# **Final Environmental Statement**

related to the operation of  
**Vogtle Electric Generating Plant,  
Units 1 and 2**

Docket Nos. 50-424 and 50-425

Georgia Power Company, et al.

Figure 4.11 Flow directions in onsite aquifer systems  
Source: ER-01 Figure 2.1-10

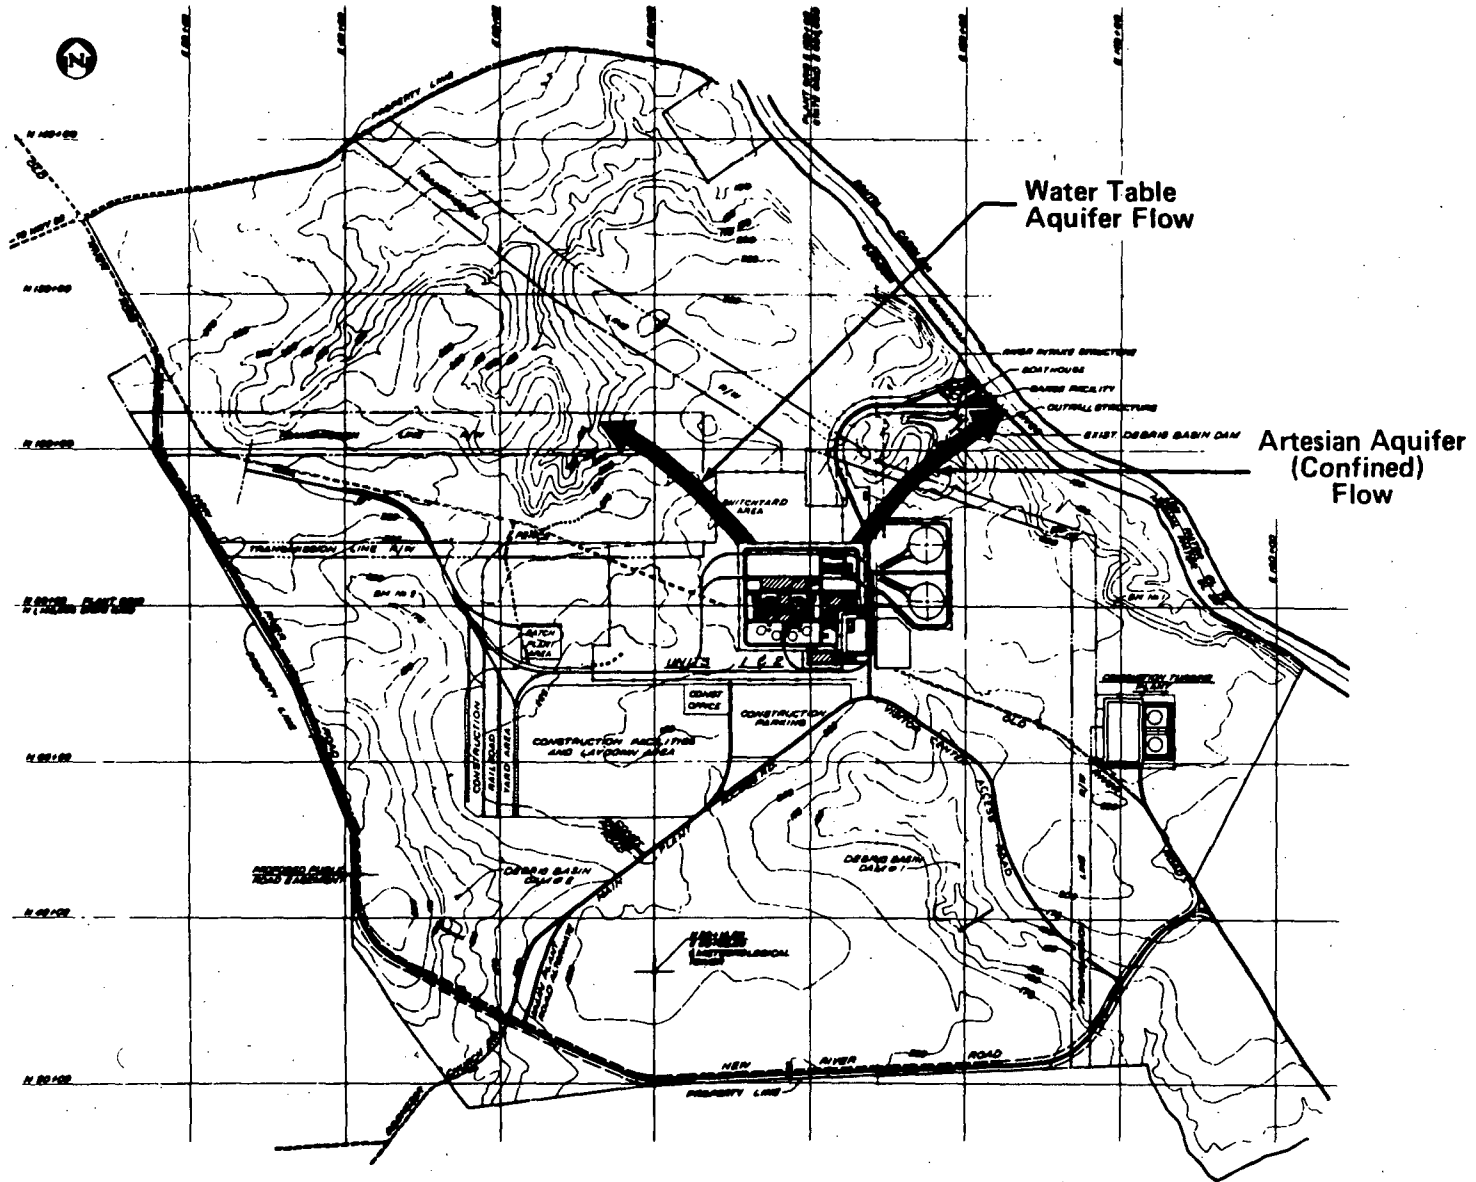
- GPC-29 Subsection 4.3.1.1, page 4-11, third paragraph.  
Should read- "None of the ground water users are located downgradient of the onsite aquifer system flowpath of a release from the powerblock area as shown on figure 4.11, and thus will not be affected by any potential radioactive liquid release at the Vogtle site.

Figure 4.11 has been revised.

The text in Section 4.3.1.2 and Figure 4.11 have been revised to reflect these changes.

Moreover, the applicant's groundwater level and flow direction investigation was not limited. The PSAR (Sections 2.4.13 and 2.5) and FSAR (Sections 2.4.12 and 2.5) contain partial documentation of the well drilling and monitoring program. However, the staff will ensure, through future FSAR amendments, that the FSAR has a complete record of all investigation and data associated with the groundwater regimes beneath Vogtle (see revised Figure 4.11 for flowpath).

Figure 4.12 Ebenezer Creek Swamp:  
alternate route  
selection  
Source: Foster, August 1984

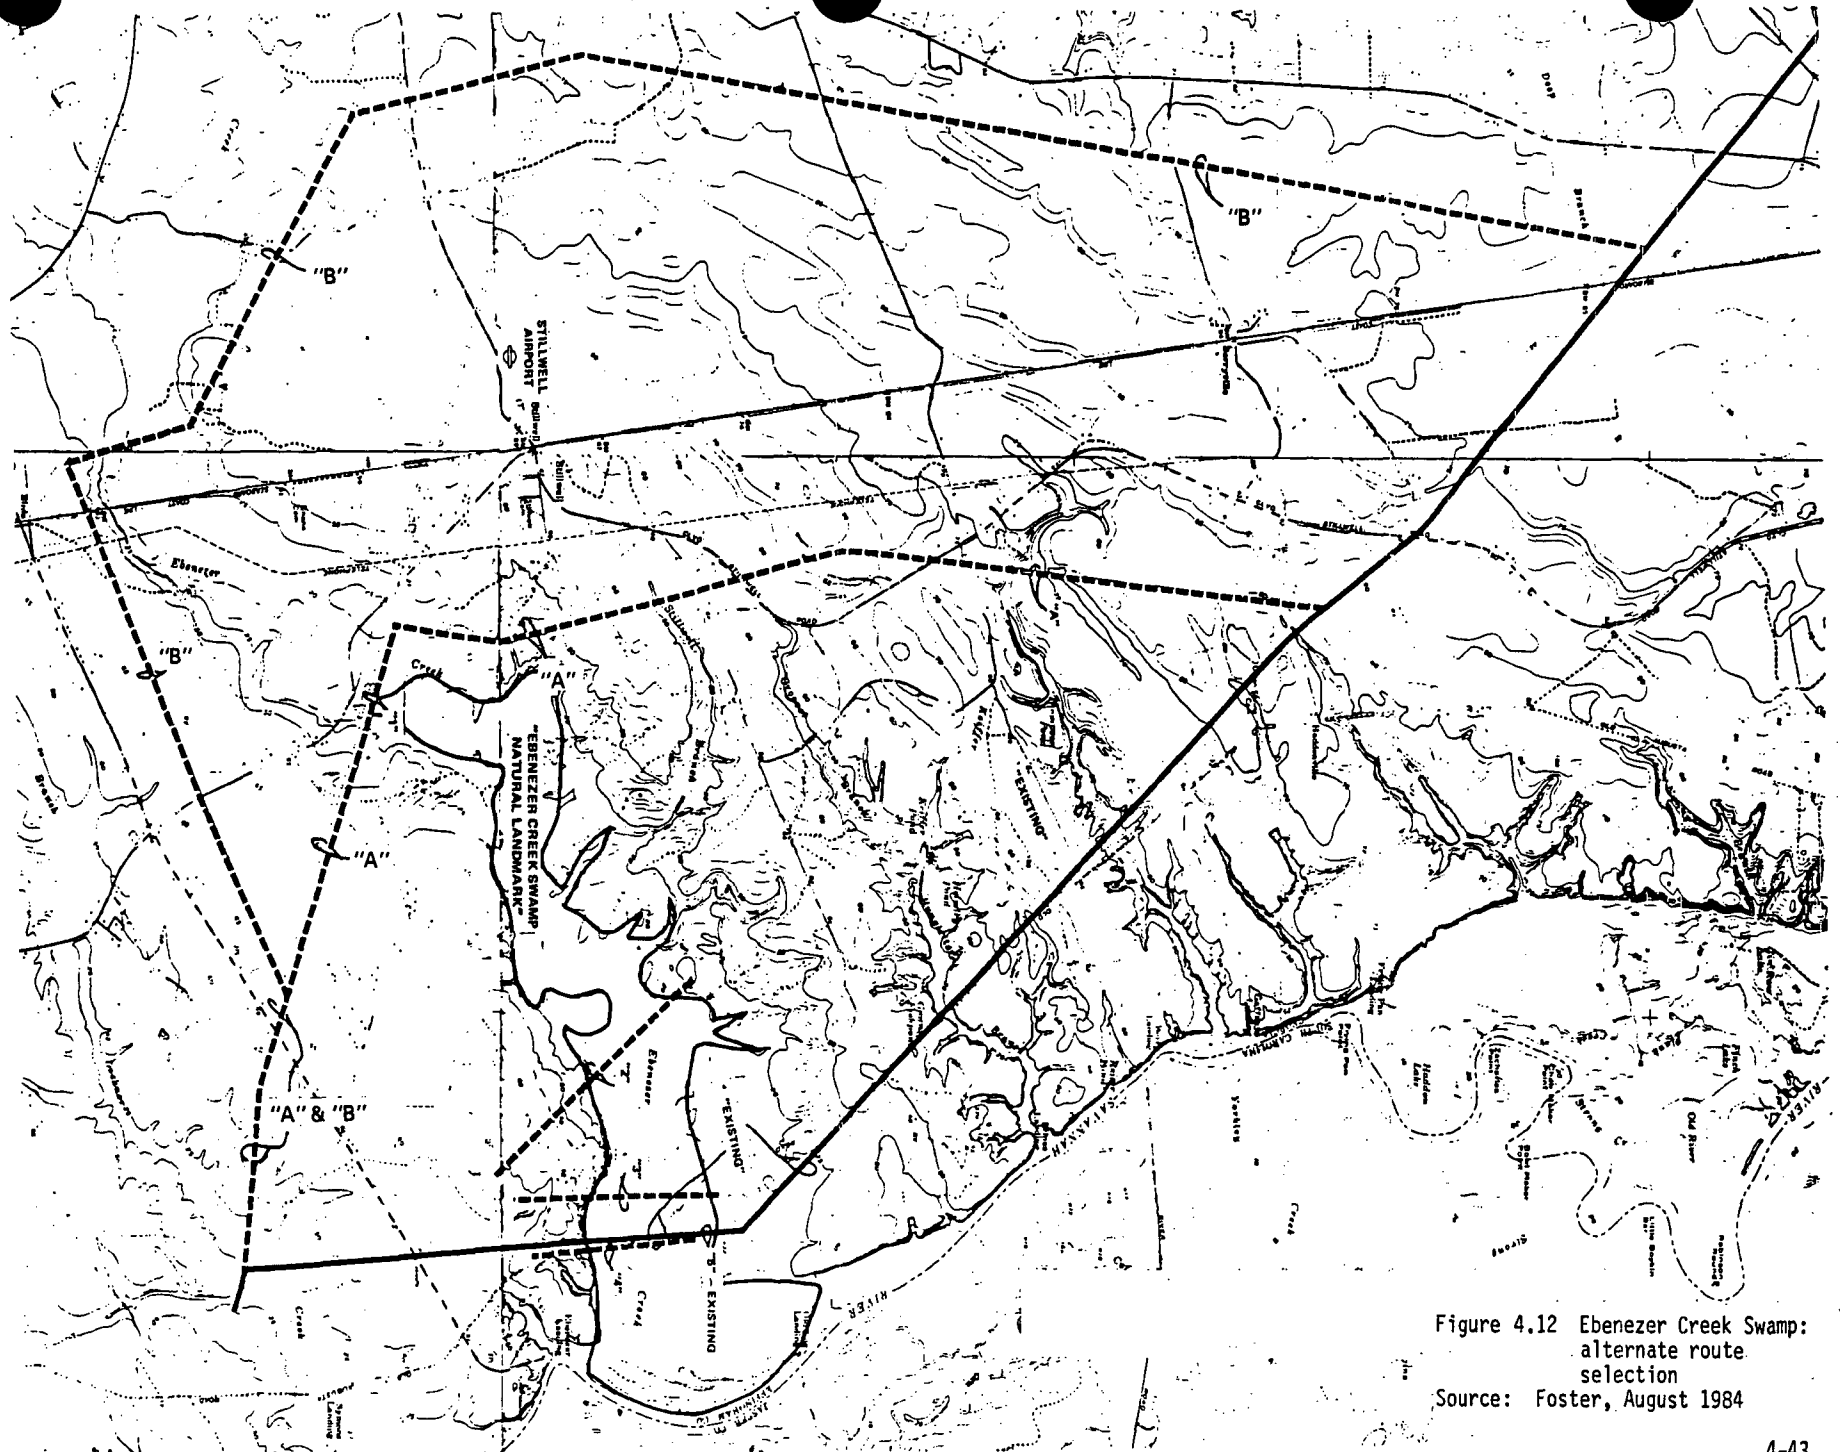
Fig. 4-12, which maps this area, is so poorly reproduced that it is extremely difficult to even determine which routes are being designated "A", "B", etc. We do not agree that the route acceptable to the US Fish & Wildlife Service is compatible with the nature of a natural landmark. If any action were appropriate, it would be the gradual elimination of any transmission lines in such an area. The fact that Georgia Power et al. would add to this intrusion may not be illegal, but it is surely not in keeping with the intent of the Landmarks Program.

Figure 5.22 Location of seven ambient noise measurement positions, 1 through 6 and 11, and key noise sources for Vogtle

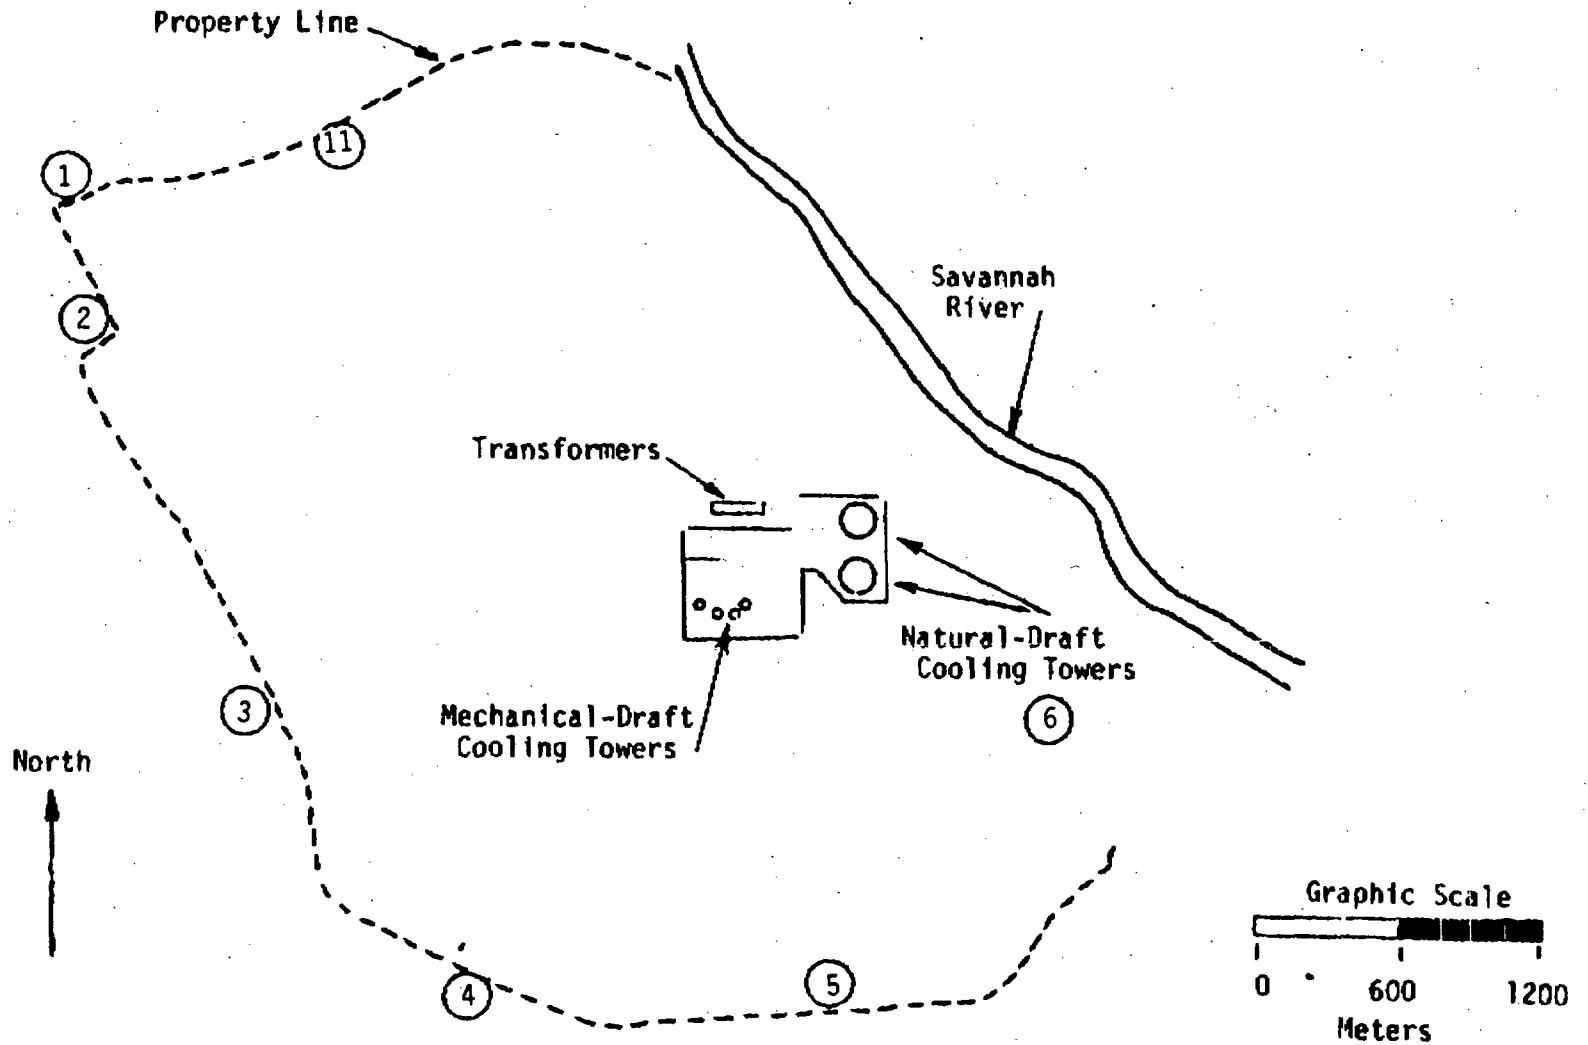
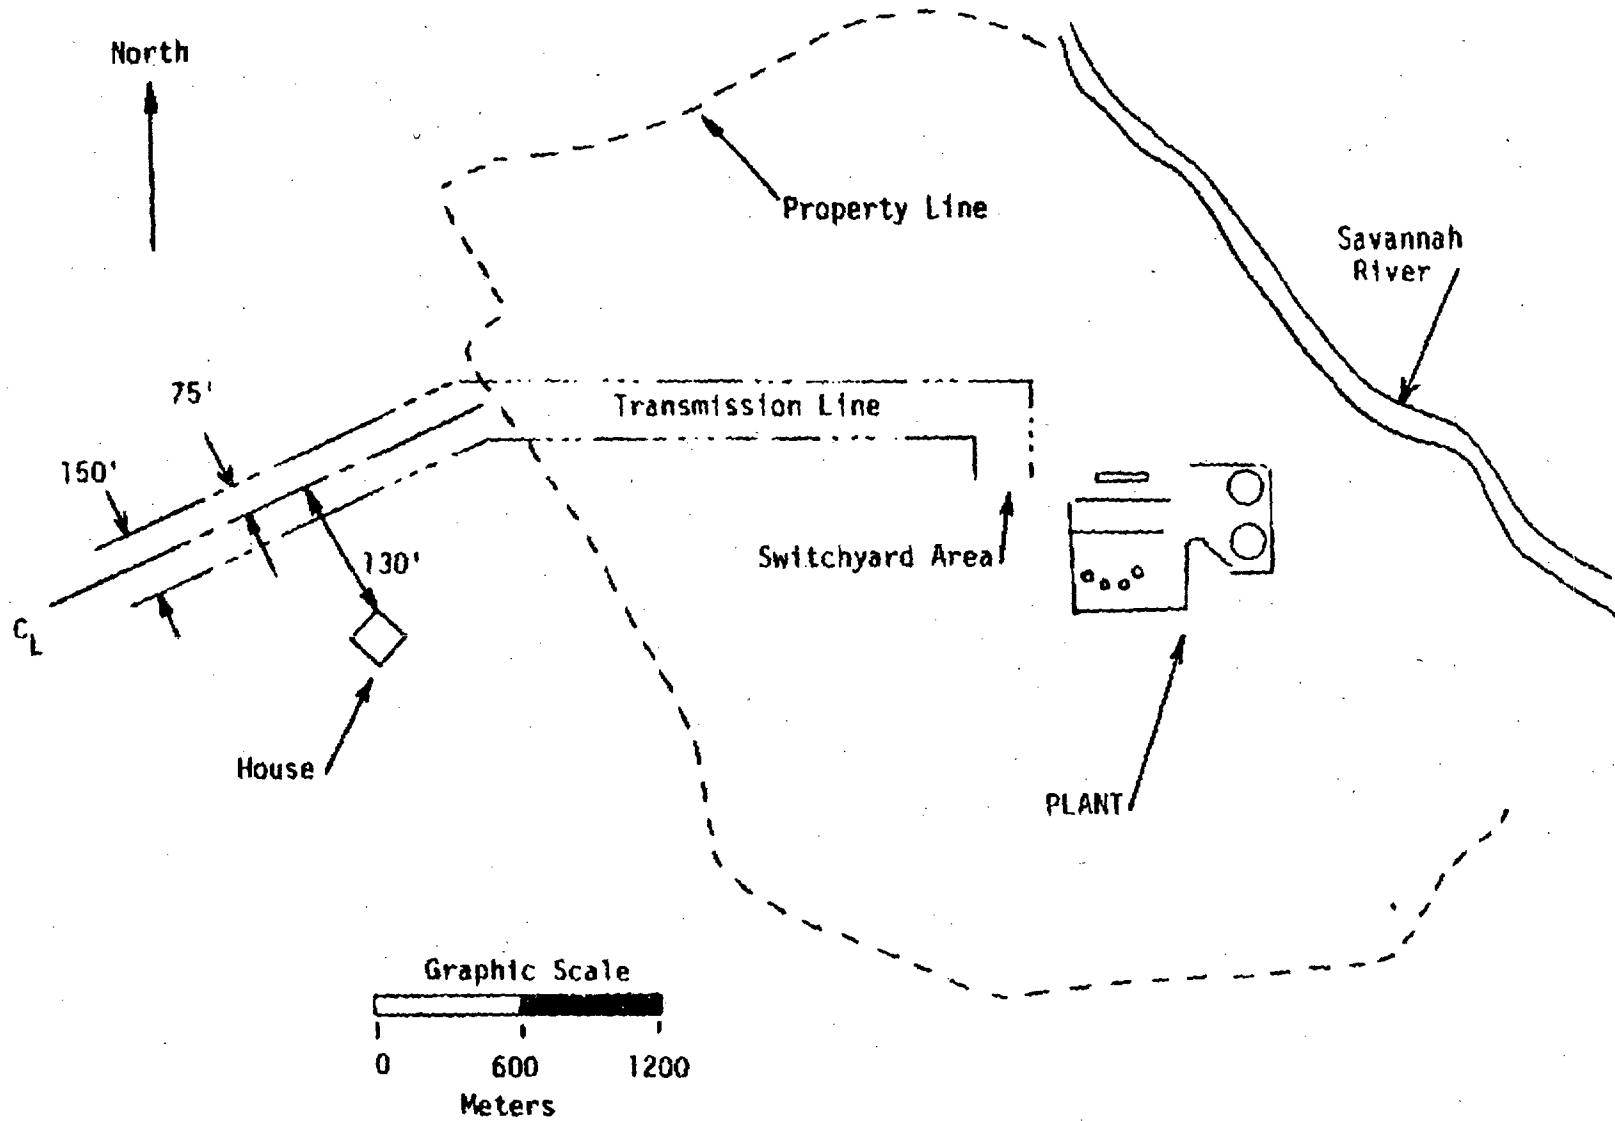
2. The staff's conclusions are based on an assumed background noise level of 24 dBA taken at location 4 on May 14, 1974. Figures 5.22 and 5.24 of the DEIS show that location 3 is closer to the home of concern. In addition, as noted in section 5.12.1 the staff used the lowest measured ambient noise level for each location as the basis for Table 5.18. It would be more appropriate to use an average noise level at the home which should be about 30 dBA in making calculations.

Location 3 (in Figure 5.22) may be closer than Location 4 to the home in question, but
